PG&E CENTRAL COAST DIVISION
ELECTRIC DISTRIBUTION AUDIT FINDINGS RESPONSE
April 21-25, 2025

I. Records Review

II. Records Violations

Figure 3: Guy slack limit, TD-2305M-JA02

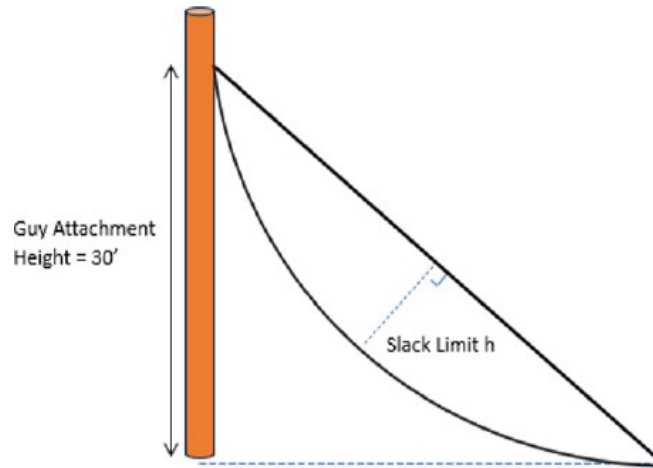
Per GO 95, Rule 56.2, guys are to be maintained taut. PG&E’s TD-2305M-JA02 allows a deviation from taut by as much as 3 feet without regard to length or angle of attachment.
